# GRID CODE REVIEW PANEL

## HV DC INTERCONNECTORS WORKING GROUP REPORT TO THE GRID CODE REVIEW PANEL

## Appendix 4 - Proposed Grid Code Modifications

Figure 2

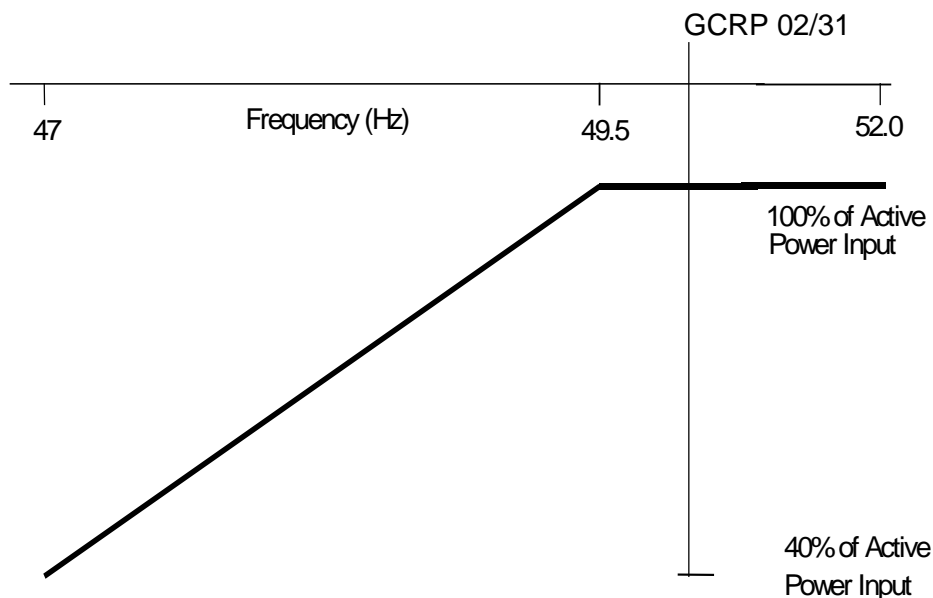
- (b)      continuously maintaining constant Active Power input (i.e., when operating in a mode analogous to Demand) from the NGC Transmission System (or User System in the case of an Embedded DC Converter Station) for System Frequency changes within the range 49.5 to 52.0 Hz as shown in Figure 2.

- (c)      maintaining its Active Power input (i.e., when operating in a mode analogous to Demand) from the NGC Transmission System (or User System in the case of an Embedded DC Converter Station) at a level not greater than the figure determined by the linear relationship shown in Figure 2 for System Frequency changes within the range 49.5 to 47 Hz, such that if the System Frequency drops to 47 Hz the Active Power input decreases by more than 60%.

Figure CC.A.3.1 - Minimum Frequency Response Requirement Profile  
 for a 0.5 Hz frequency change from Target Frequency  
 GCRP 02/31

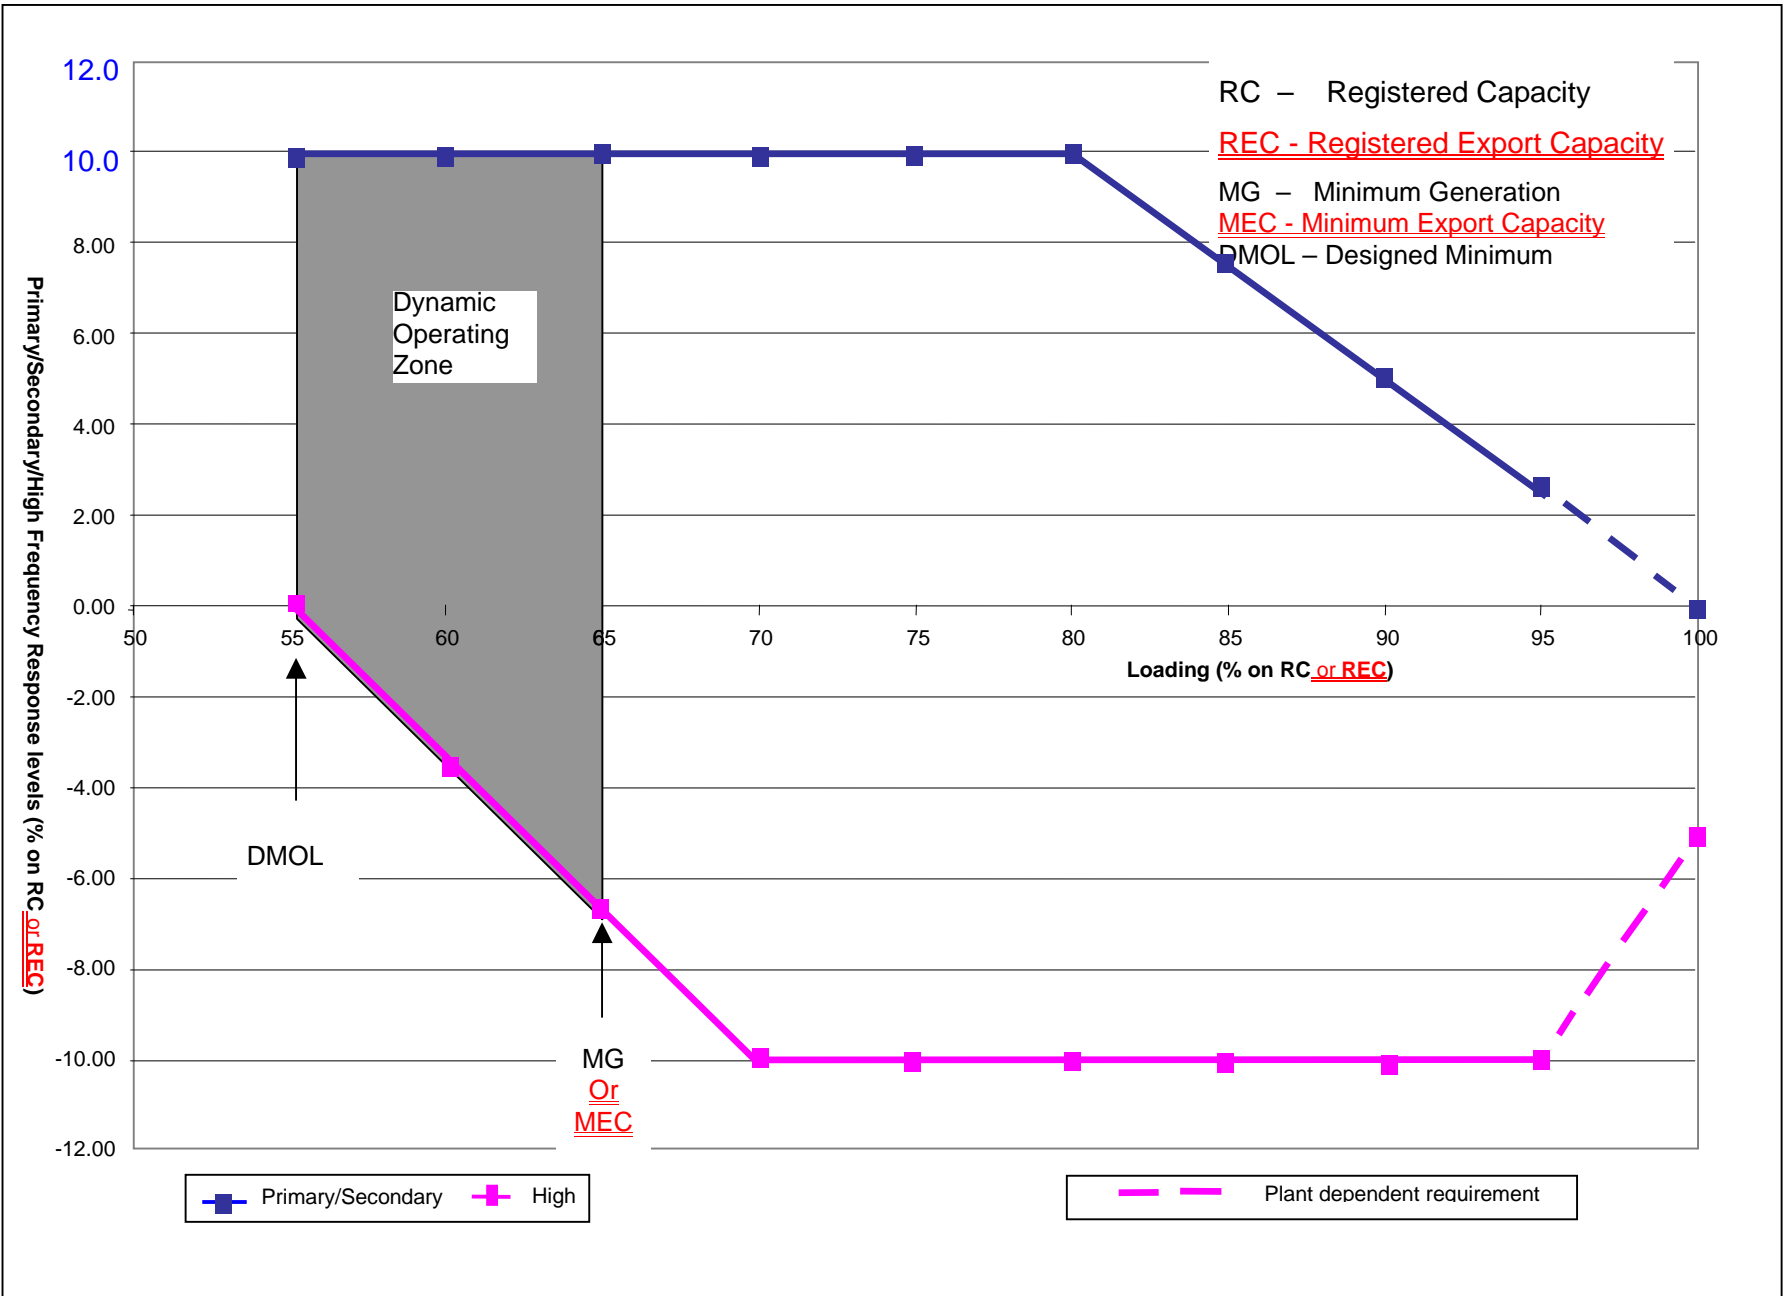
Each **Generating Unit** ~~and/or~~ **CCGT Module** or DC Converter Station must be capable of providing some response, in keeping with its specific operational characteristics, when operating between 95% to 100% of **Registered Capacity** (or Registered Export Capacity) as illustrated by the dotted lines in Figure CC.A.3.1.

At the **Minimum Generation** level, each **Generating Unit** and/or **CCGT Module** is required to provide high and low frequency response depending on the **System Frequency** conditions. At the Minimum Export Capacity level, each DC Converter Station is required to be capable of providing high and low frequency response depending on the System Frequency conditions. Where the **Frequency** is high, the **Active Power** output is therefore expected to fall below the **Minimum Generation** (or Minimum Export Capacity) level.

The **Designed Minimum Operating Level** is the output at which a **Generating Unit** ~~and/or~~ **CCGT Module** or DC Converter Station has no **High Frequency Response** capability. It may be less than, but must not be more than, 55% of the **Registered Capacity** (or Registered Export Capacity). This implies that a **Generating Unit** ~~or~~ **CCGT Module** or DC Converter Station is not obliged to reduce its output to below this level unless the **Frequency** is at or above 50.5 Hz (cf BC3.7).

Figure CC.A.3.2 - Interpretation of Primary and Secondary Response Values

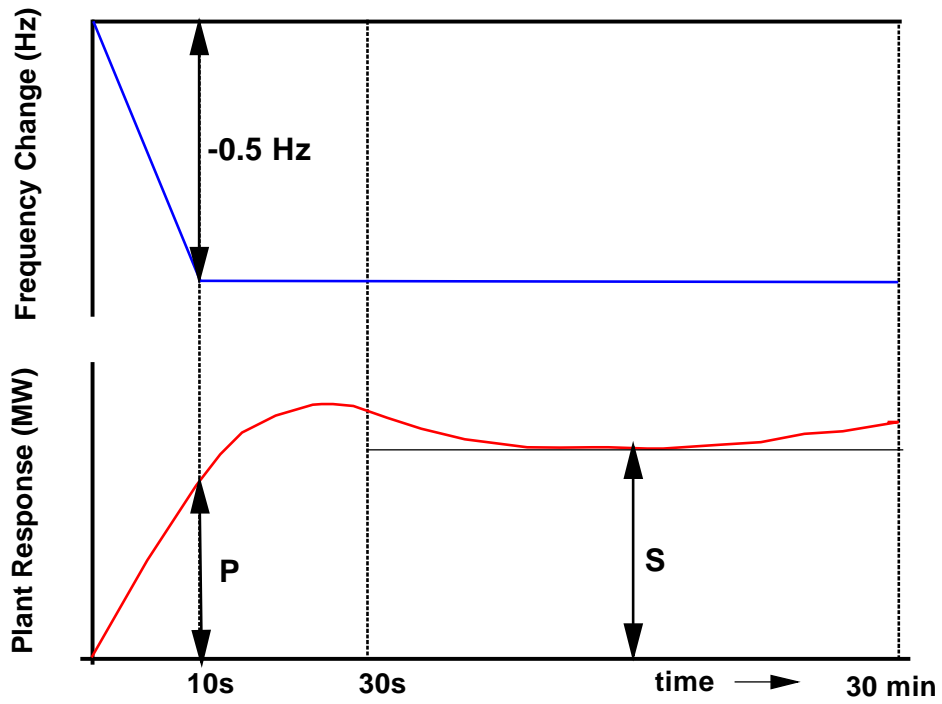
The **Primary Response** capability (P) of a **Generating Unit~~-or-a~~, CCGT Module or DC Converter Station** is the minimum increase in **Active Power** output between 10 and 30 seconds after the start of the ramp injection as illustrated diagrammatically in Figure CC.A.3.2.

The **Secondary Response** capability (S) of a **Generating Unit~~-or-a~~, CCGT Module or DC Converter Station** is the minimum increase in **Active Power** output between 30 seconds and 30 minutes after the start of the ramp injection as illustrated diagrammatically in Figure CC.A.3.2.

Figure CC.A.3.3 - Interpretation of High Frequency Response Values

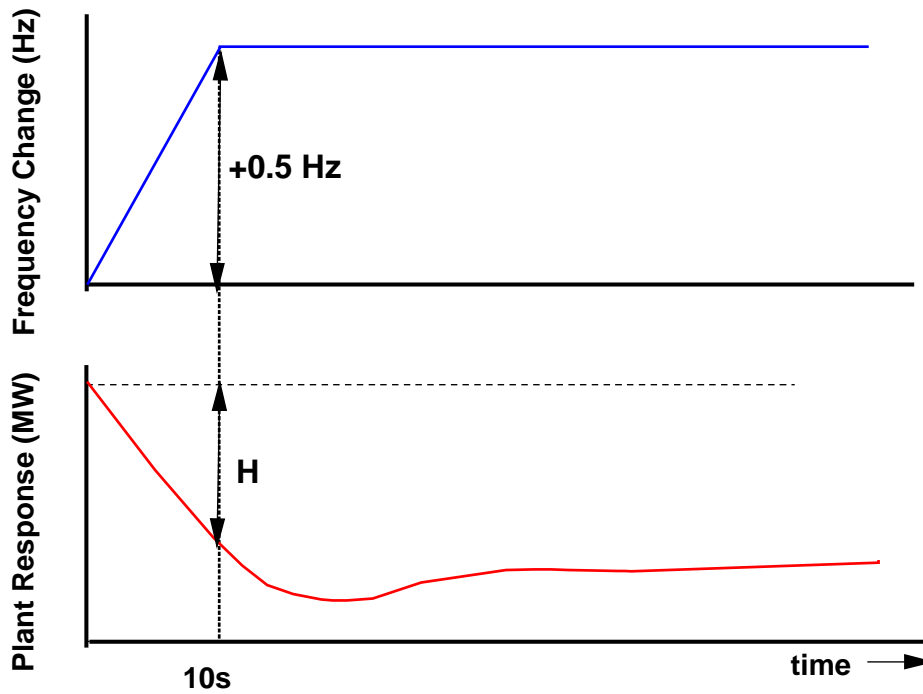
The **High Frequency Response** capability (H) of a **Generating Unit~~-or-a~~, CCGT Module or DC Converter Station** is the decrease in **Active Power** output provided 10 seconds after the start of the ramp injection and sustained thereafter as illustrated diagrammatically in Figure CC.A.3.3.
